## Contract Change Order # 3

Project Name: <u>Old Town Streets; Rehab of Ash Ave.</u>	Project Number: <u>ST1711</u>
Project Location: <u>Ave Ave. Between El Paso and College</u>	Date of Application: <u>Tuesday, May 28, 2019</u>
Contractor: <u>H &amp; G Paving</u>	Submitted By: <u>Greg H.</u>

OLD TOWN STREETS  
ASH AVE. AND EL PASO ST.  
IMPROVEMENTS

QUANTITIES,NOTES AND  
DETAILS

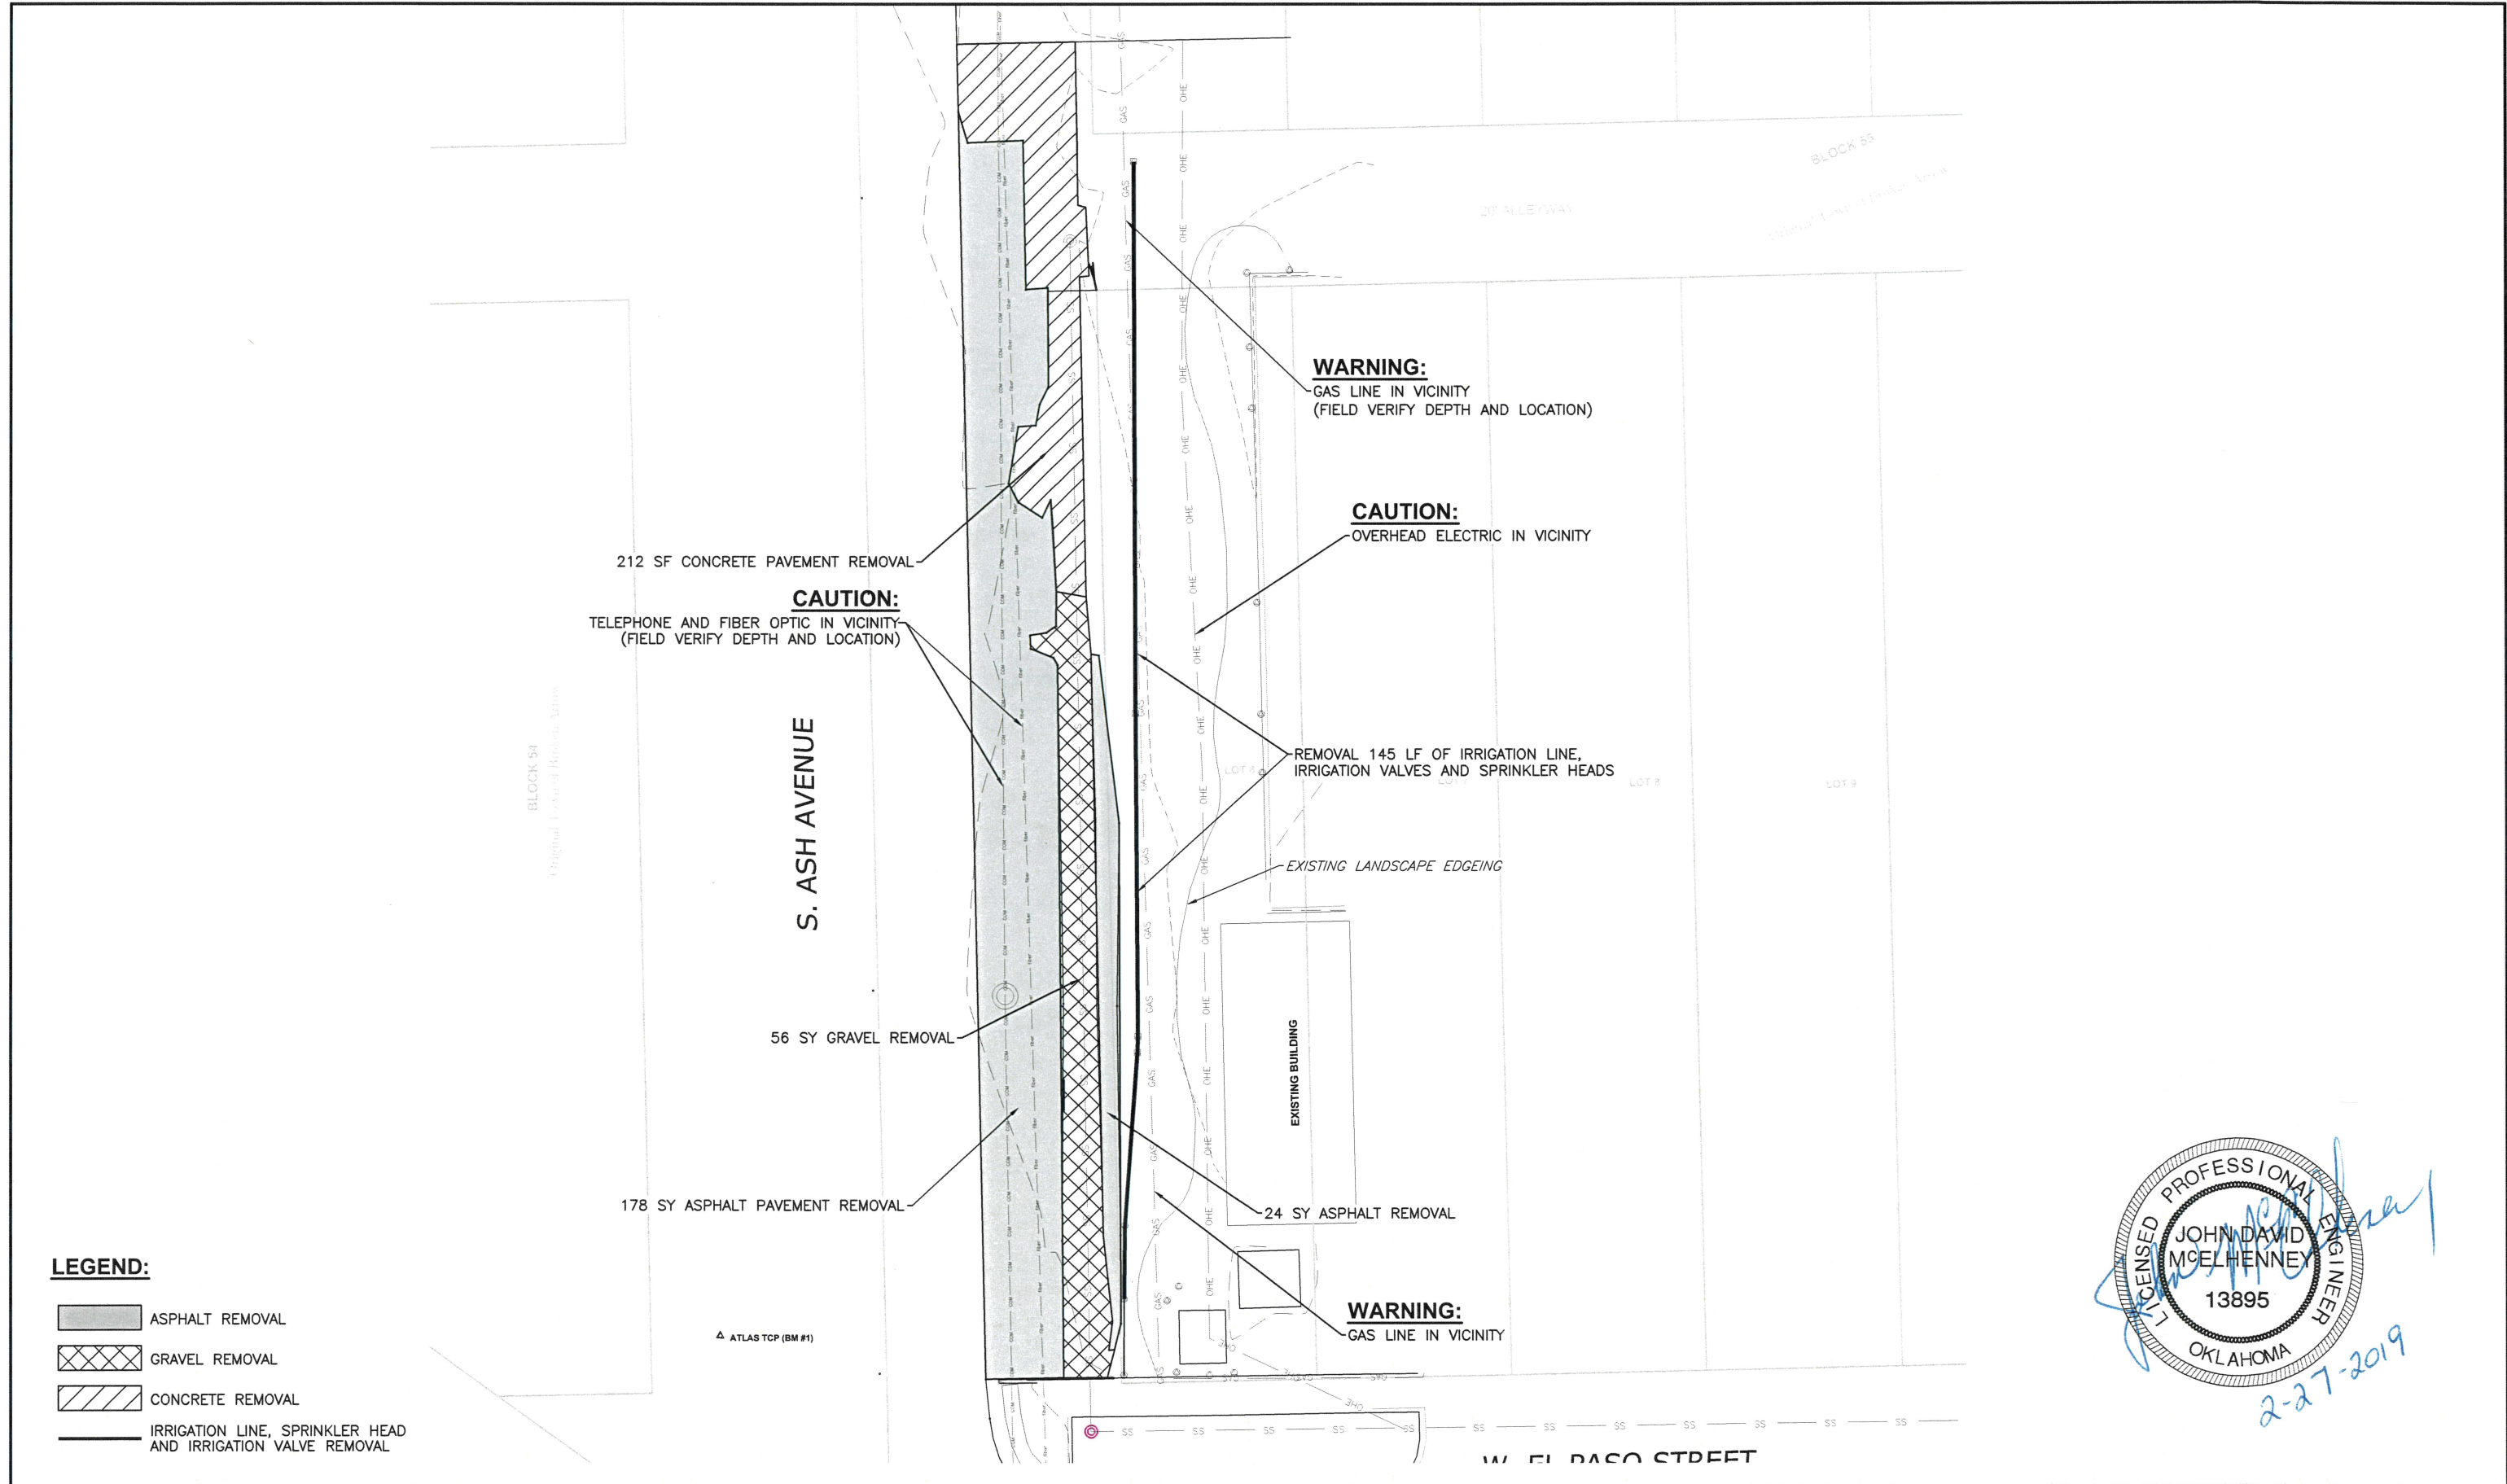
- As directed by COBA, the contractor is to install the additional parking along Ash St. between El Paso St. and Dallas Street. The contractor is to install this new section following the attached plan sheets issued by the City of Broken Arrow. The contractor has agreed
- 1) to utilize existing line items to construct the new pavement section with this change order covering the re-mobilization and out of scope services; irrigation relocation efforts. The attached proposal from the contractor covers the costs to remobilize back onsite to perform the required work as well as relocate the effected irrigation lines complete in place.
